LANDLORD SUBMISSION SET:
3-15-13

ZAVINO UNIVERSITY CITY
3200 CHESTNUT STREET, UNIT B
PHILADELPHIA, PA

1
A-101
FIRST FLOOR PLAN
SCALE: 1/4" = 1'-0"

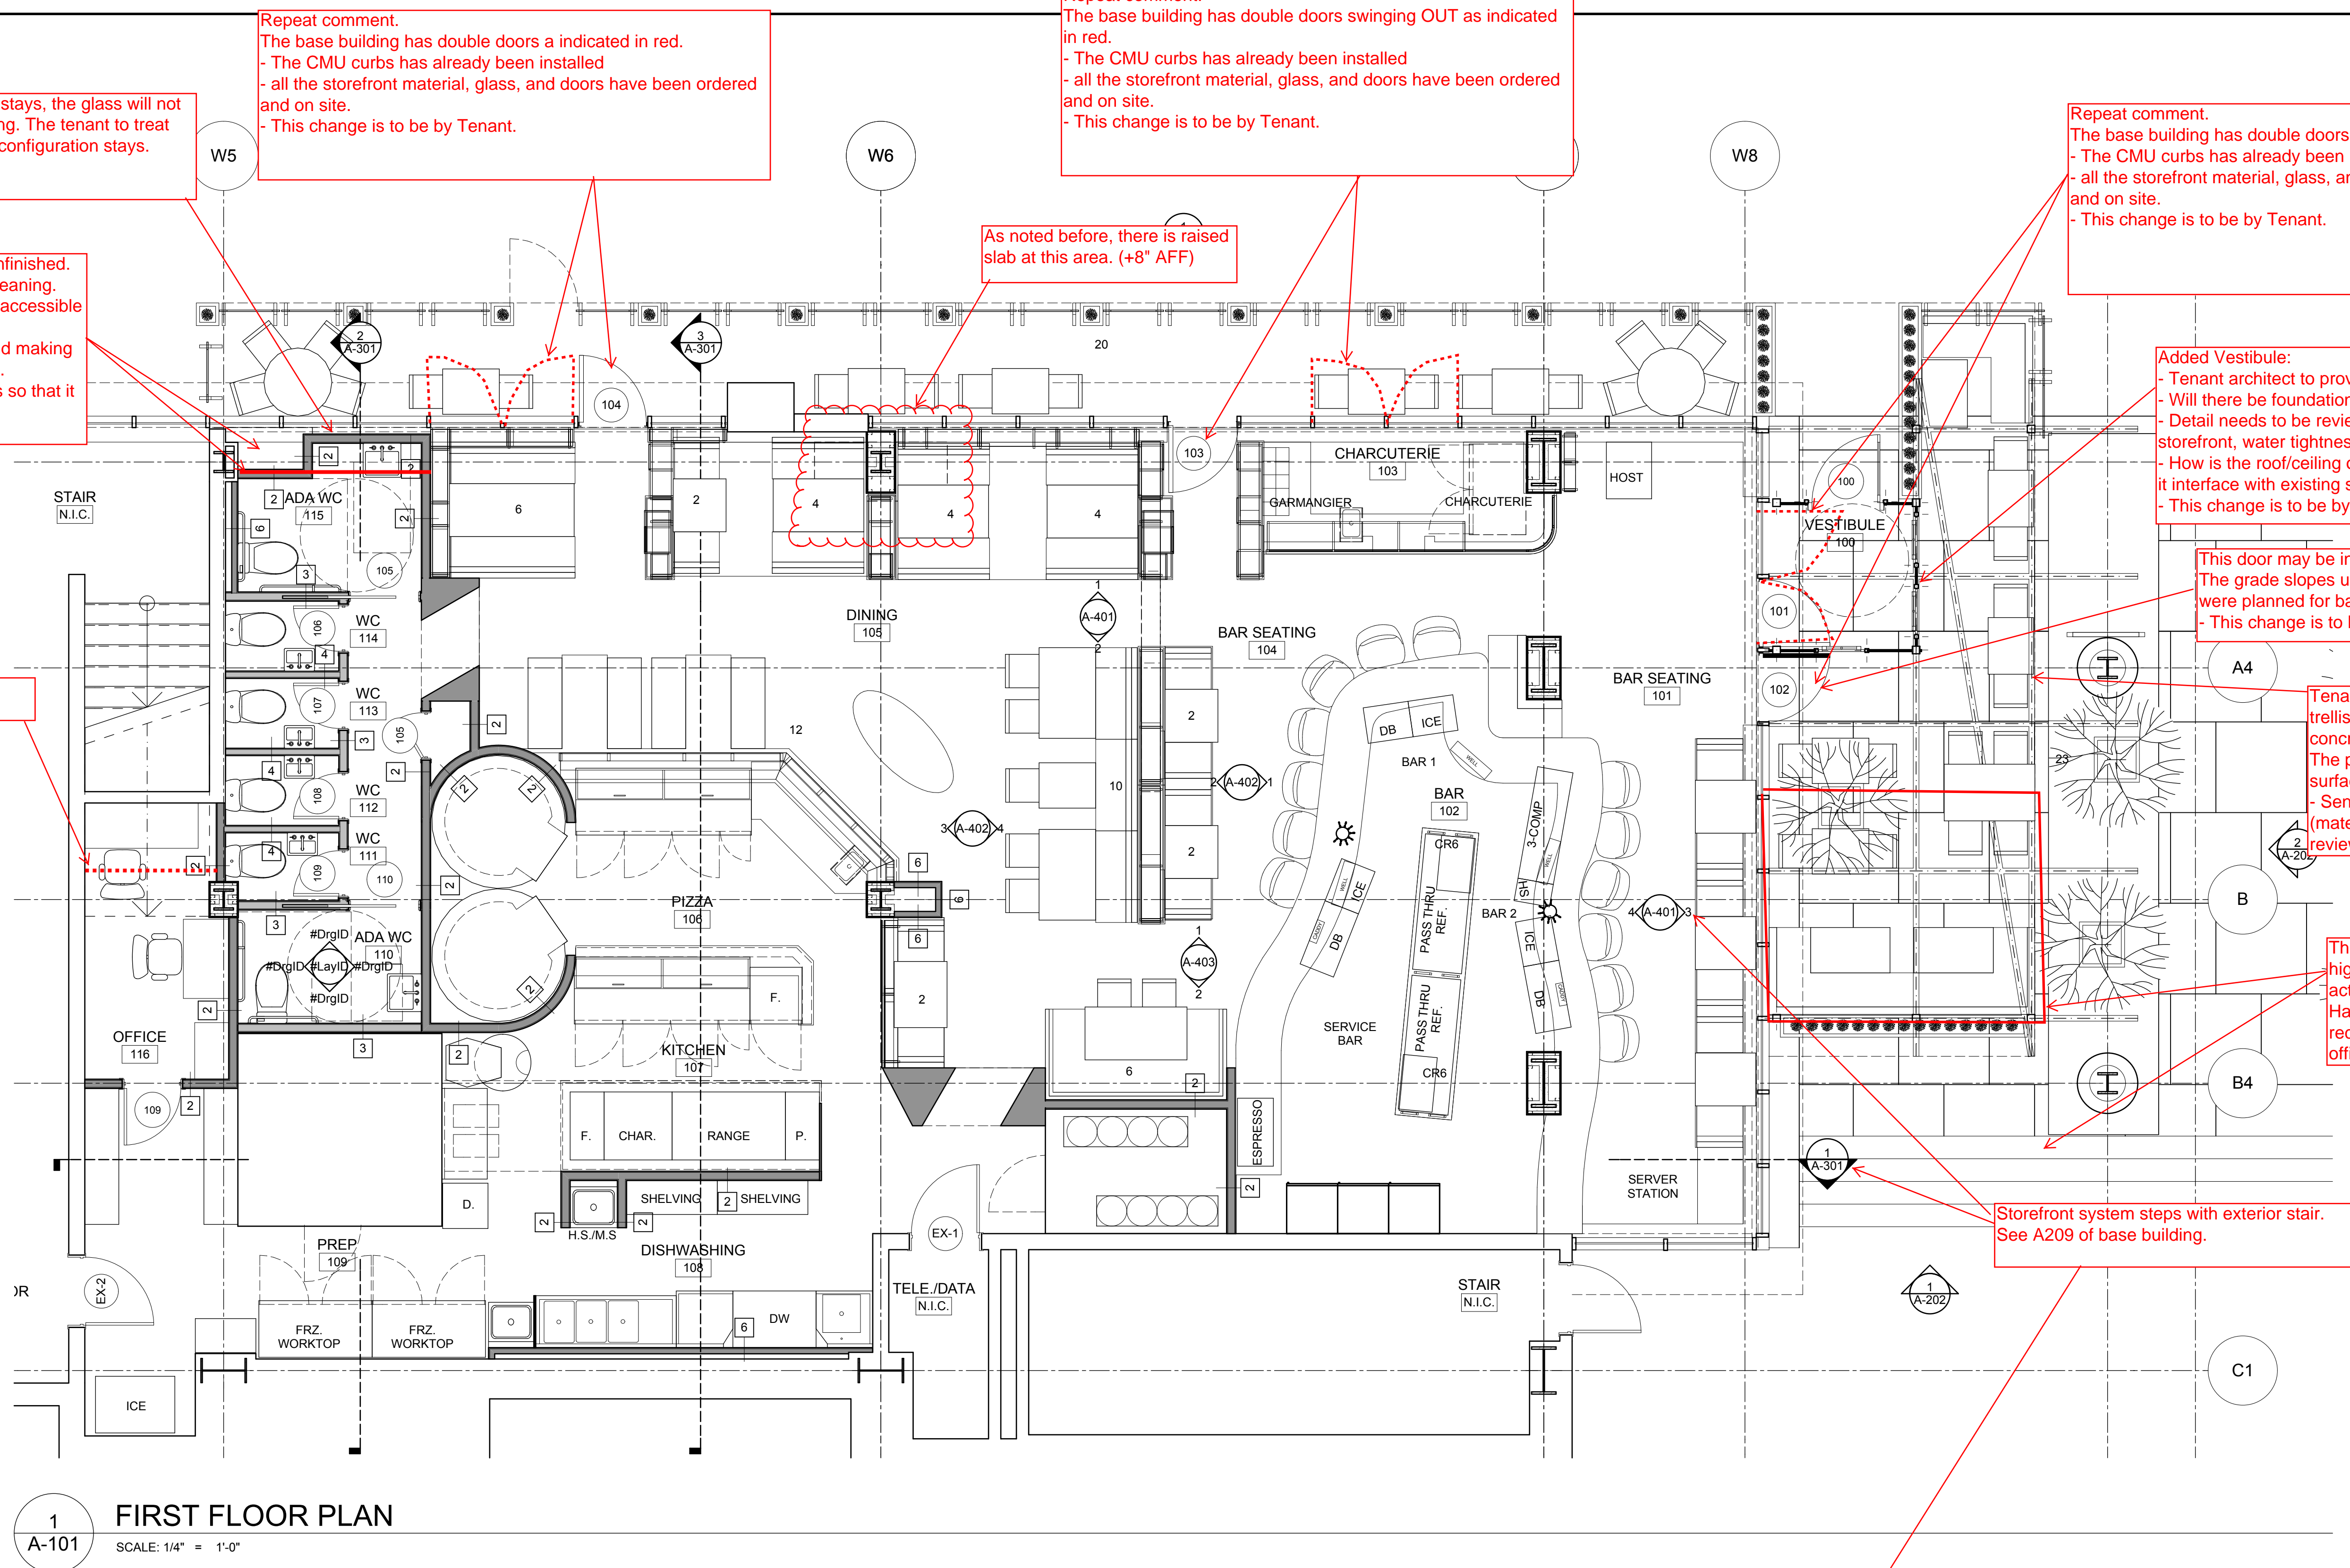
If this wall configuration stays, the glass will not be accessible for cleaning. The tenant to treat the glass opaque if this configuration stays.

Repeat comment.
The base building has double doors as indicated in red.
- The CMU curbs has already been installed
- all the storefront material, glass, and doors have been ordered and on site.
- This change is to be by Tenant.

Repeat comment.
The base building has double doors swinging OUT as indicated in red.
- The CMU curbs has already been installed
- all the storefront material, glass, and doors have been ordered and on site.
- This change is to be by Tenant.

Repeat comment.
The base building has double doors as indicated in red.
- The CMU curbs has already been installed
- all the storefront material, glass, and doors have been ordered and on site.
- This change is to be by Tenant.

Added Vestibule:
- Tenant architect to provide detail of the vestibule.
- Will there be foundation and slab?
- Detail needs to be reviewed for how it will tie into the existing storefront, water tightness etc.
- How is the roof/ceiling of the vestibule detailed? and how does it interface with existing storefront and watertight line?
- This change is to be by Tenant.

This door may be in conflict with grading (miniscule).
The grade slopes up towards south from where the double doors were planned for base-building.
- This change is to be by Tenant.

Tenant architect to make sure that the trellis posts are not cored through the concrete.
The posts for the Trellis should be surface mounted. Verify detail
- Send additional information on Trellis (material, detail, and etc) for ACC to review.

This is a gray area but technically the highlighted area needs to be clear to act as landing for the exterior stair.
Have flexible design so that it can be reconfigured if pointed out by the code official.

The niche is bare concrete (raised), unfinished. It will collect dust without access for cleaning. The storefront at this niche will not be accessible for cleaning or maintenance. We suggest this wall to run straight and making the area utilized for display or signage. If not, the tenant should treat the glass so that it is opaque.

1 REFLECTED CEILING PLAN
A-102 SCALE: 1/4" = 1'-0"

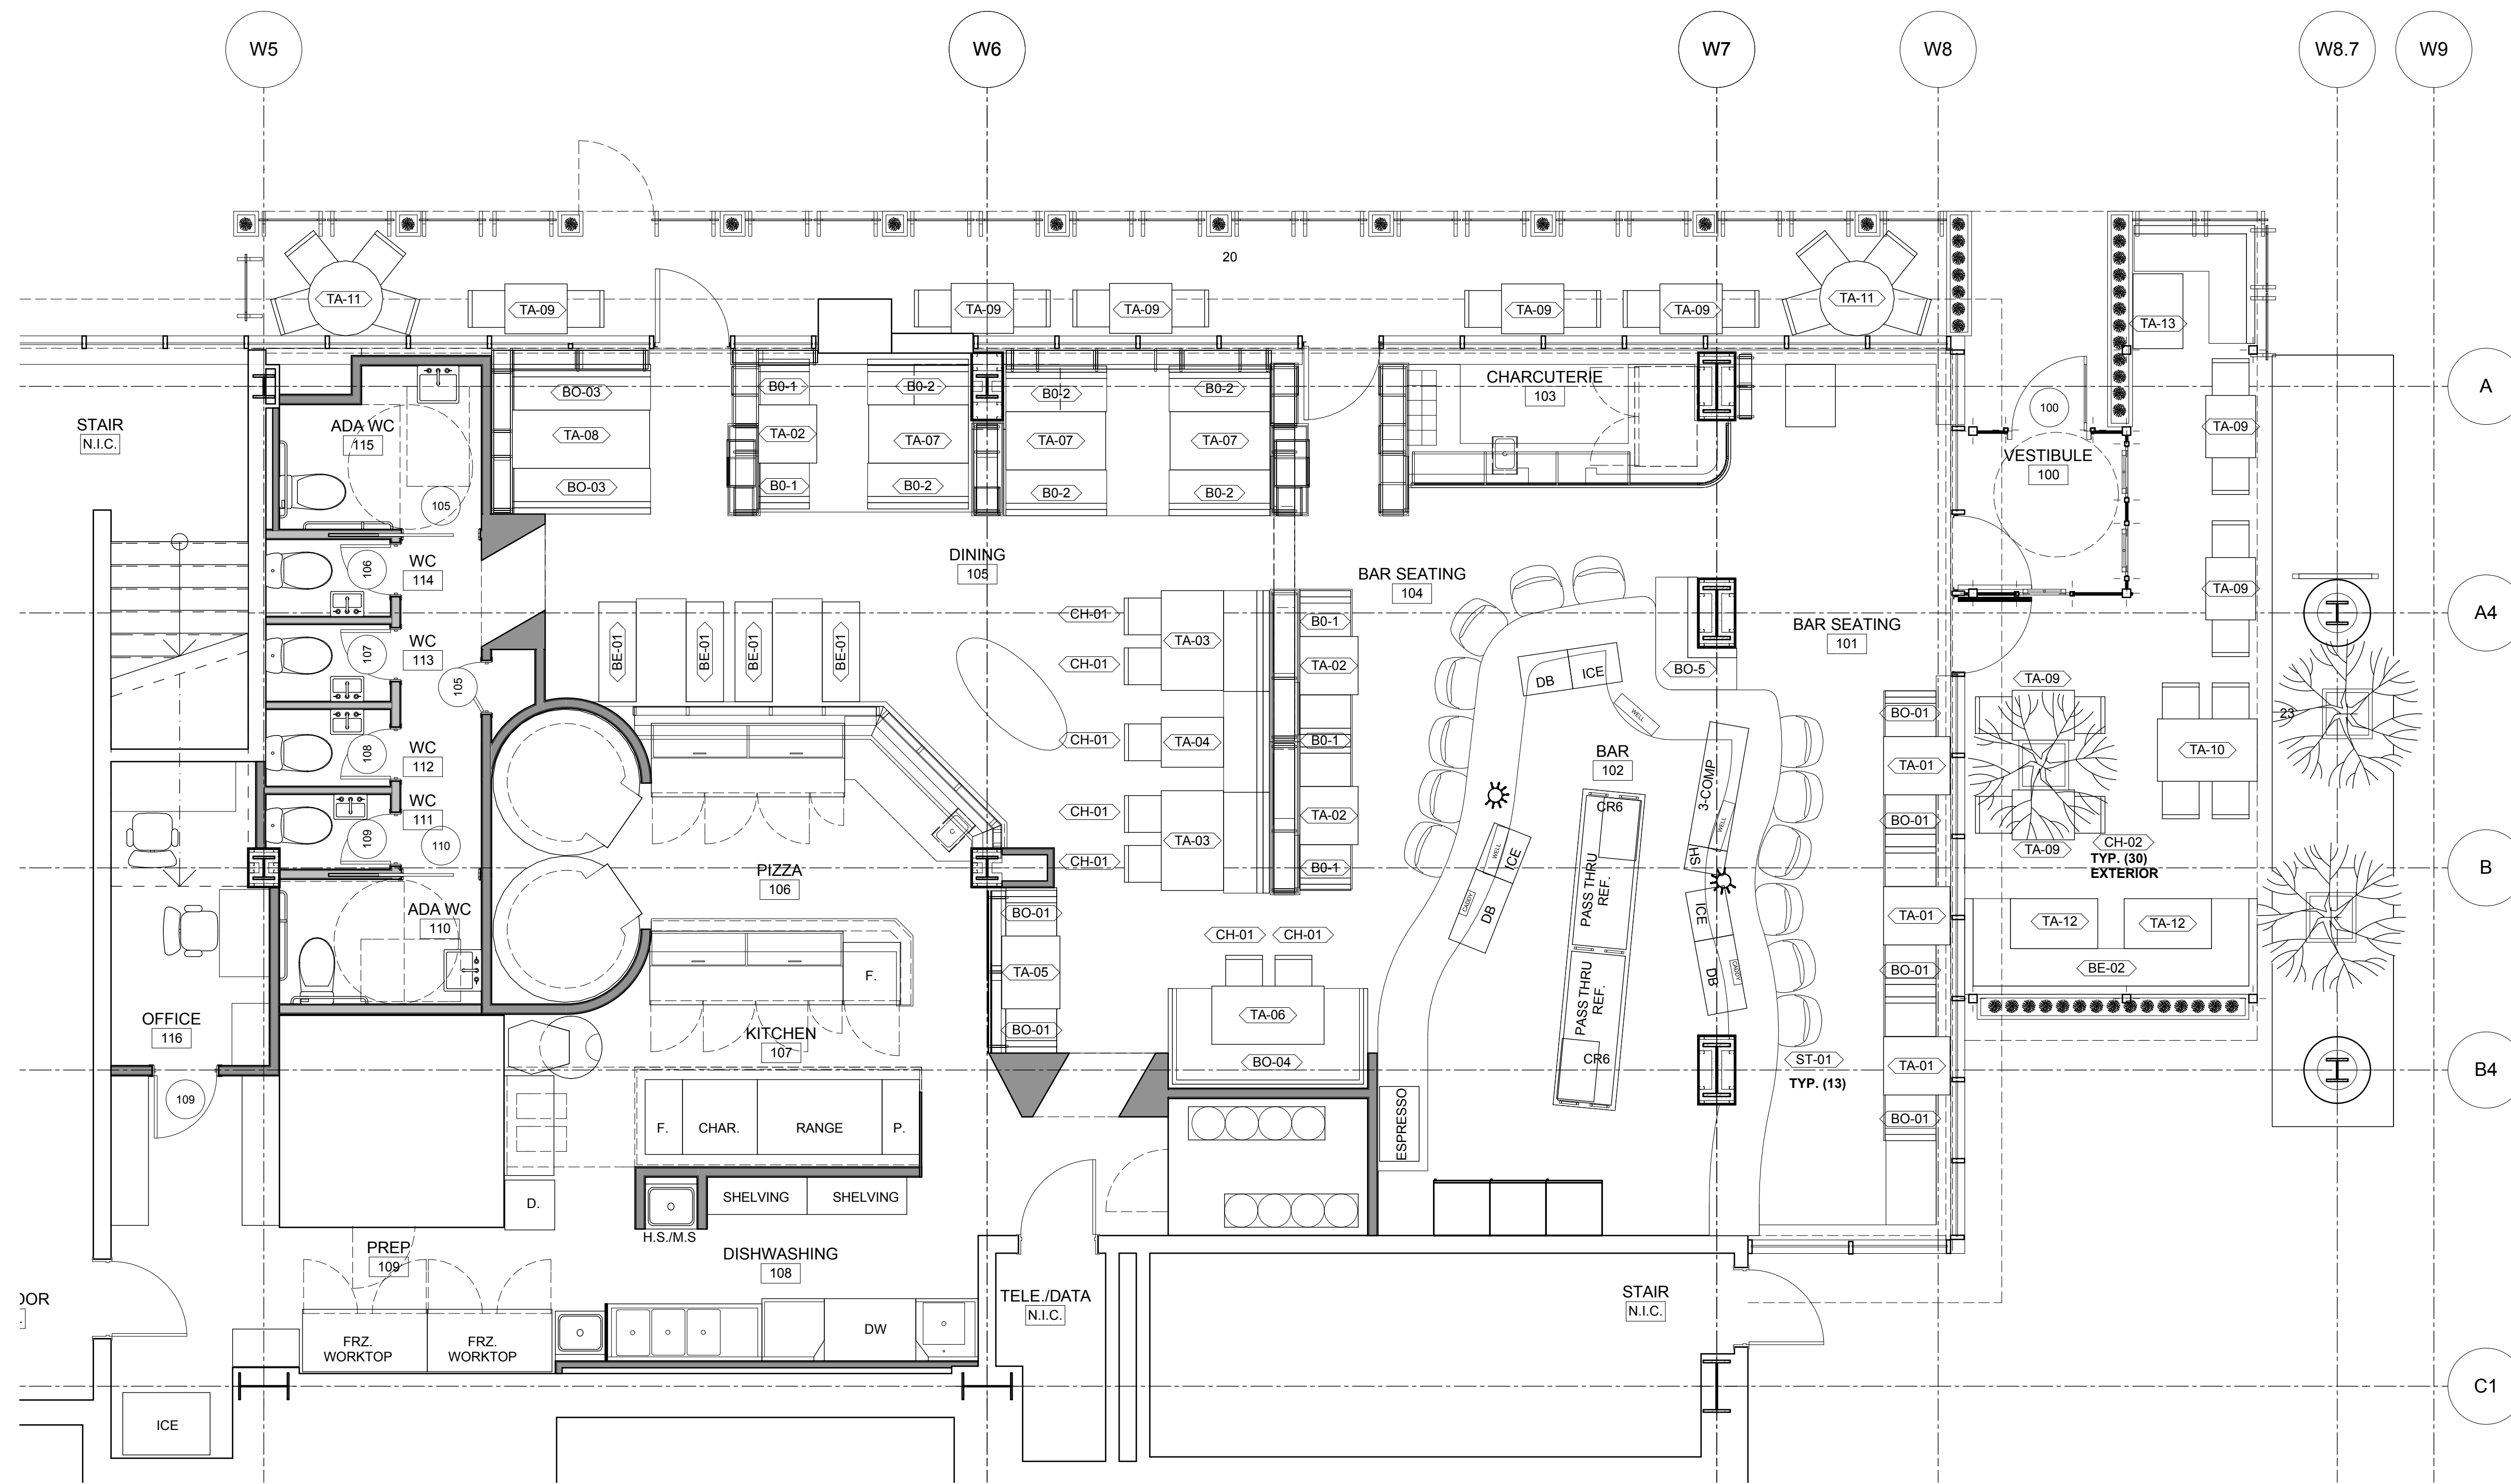
Note that the head clearance of 6'-8" occurs approximately 12" North of column line B.

Note that there is not a ceiling in the base building. It is exposed to structure, with fireproofing on the beams.

1 SOUTH ELEVATION
A-202 SCALE: 1/4" = 1'-0"

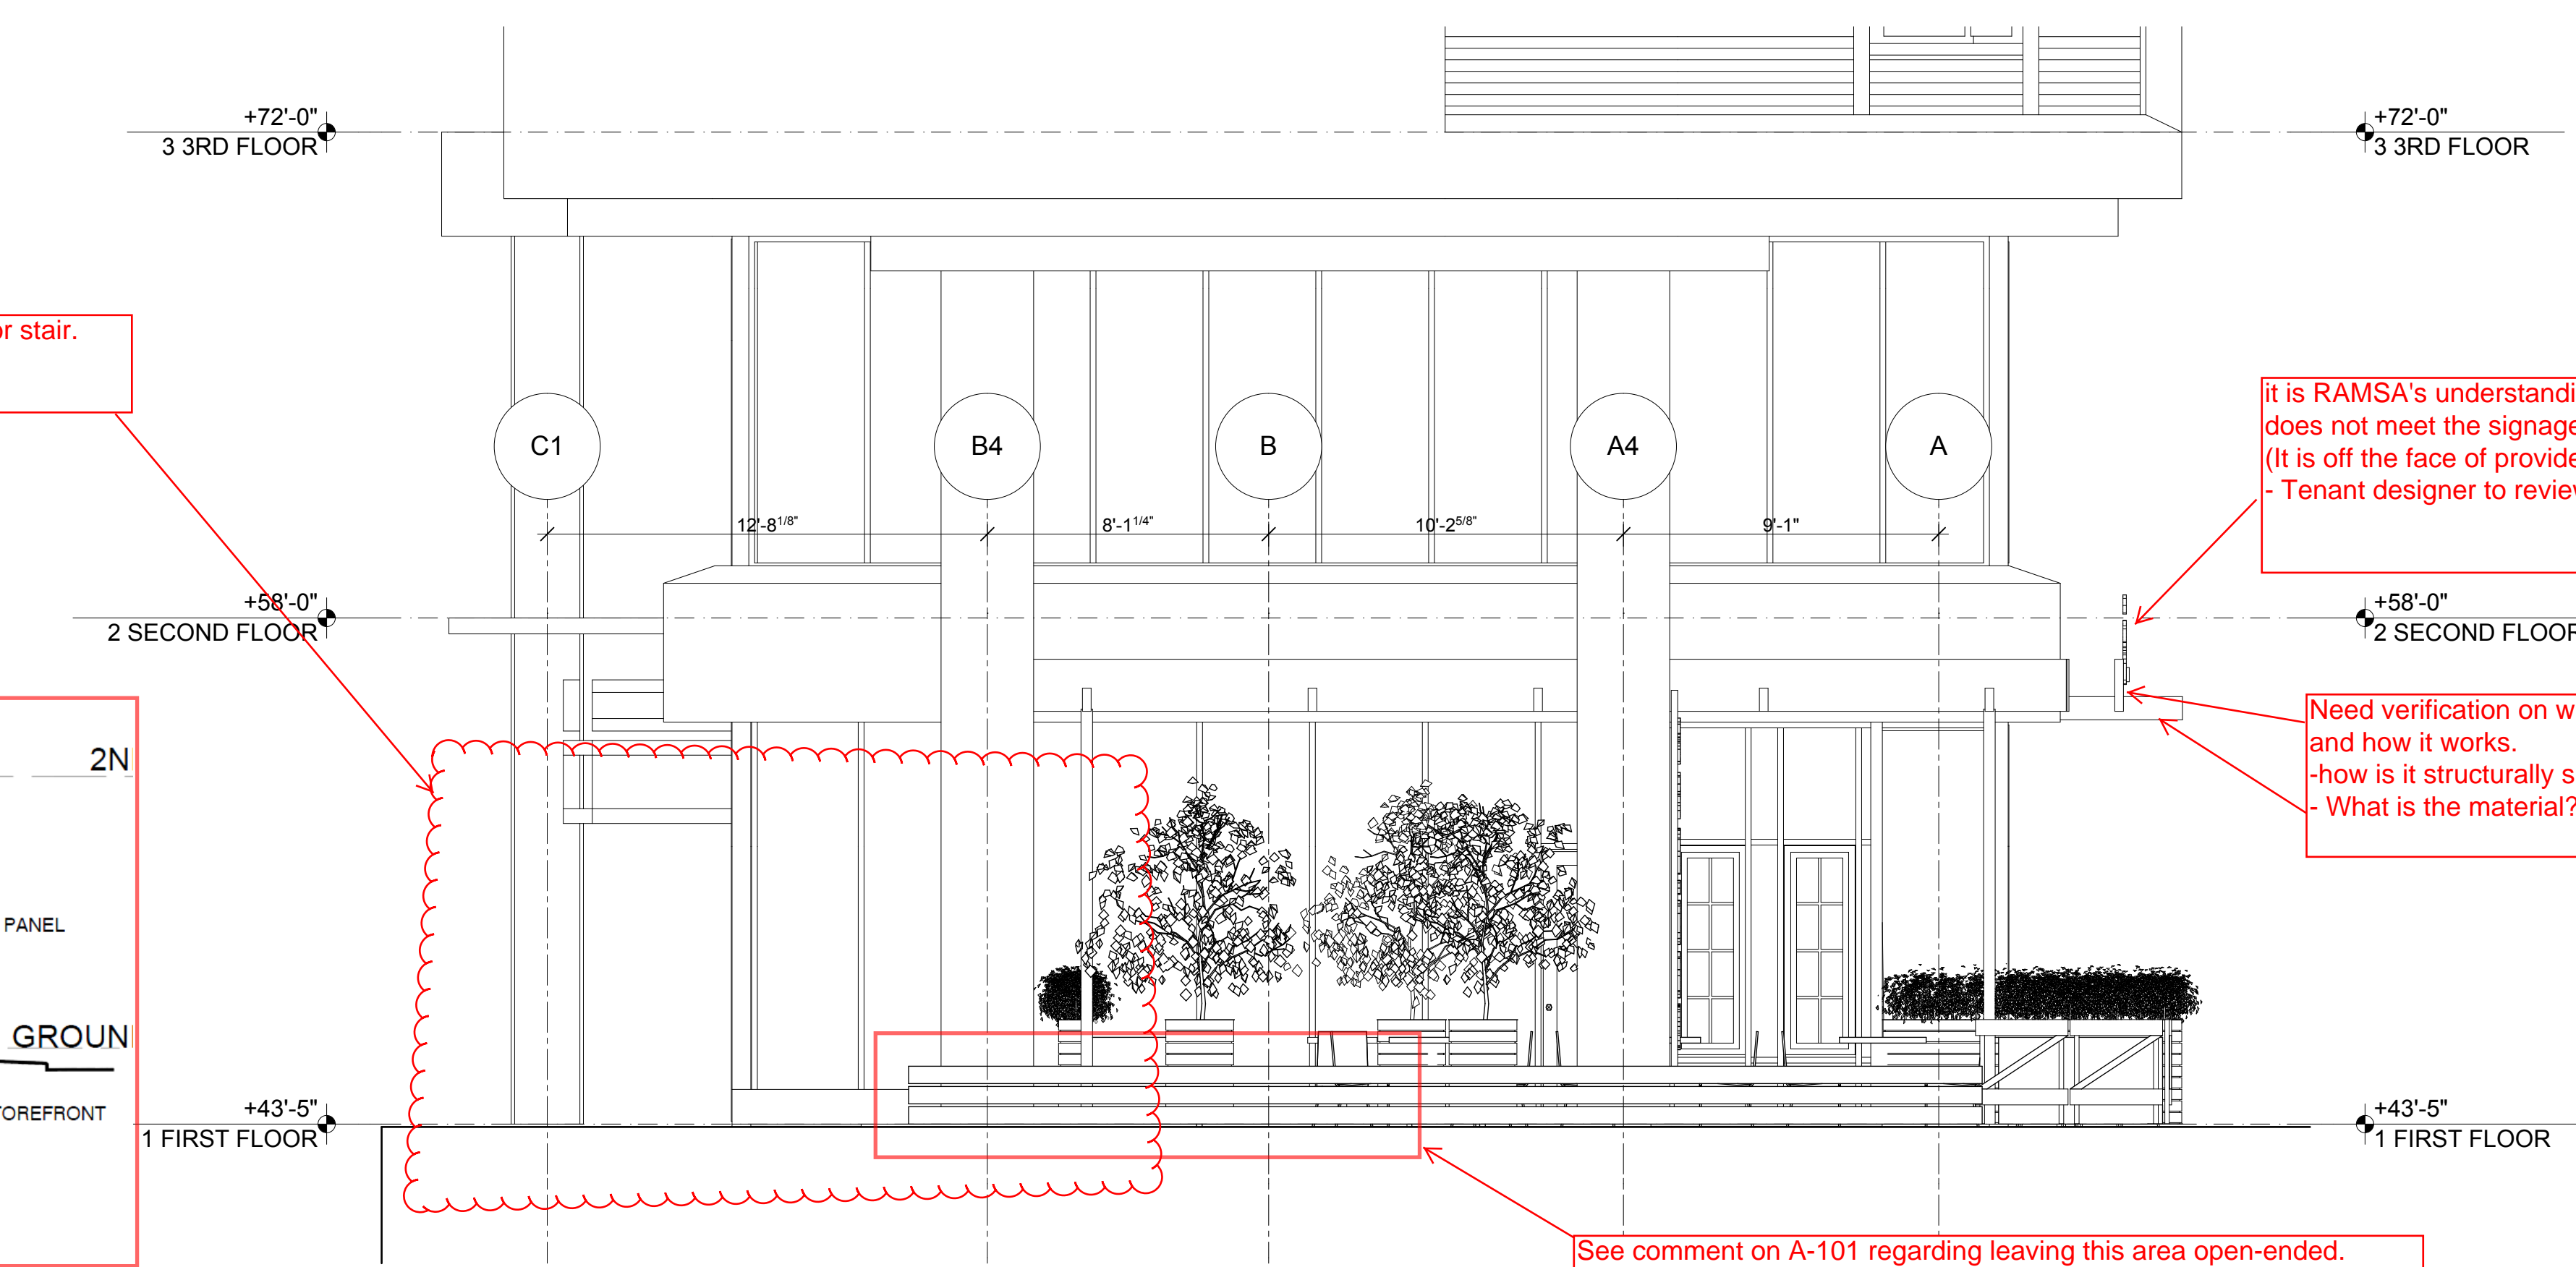
Storefront system steps with exterior stair.
See A209 of base building.

it is RAMSA's understanding that this signage
does not meet the signage criteria.
(It is off the face of provided ACM signage band)
- Tenant designer to review signage with ACC

Need verification on what this band is (material)
and how it works.
-how is it structurally supported?
- What is the material?

See comment on A-101 regarding leaving this area open-ended.
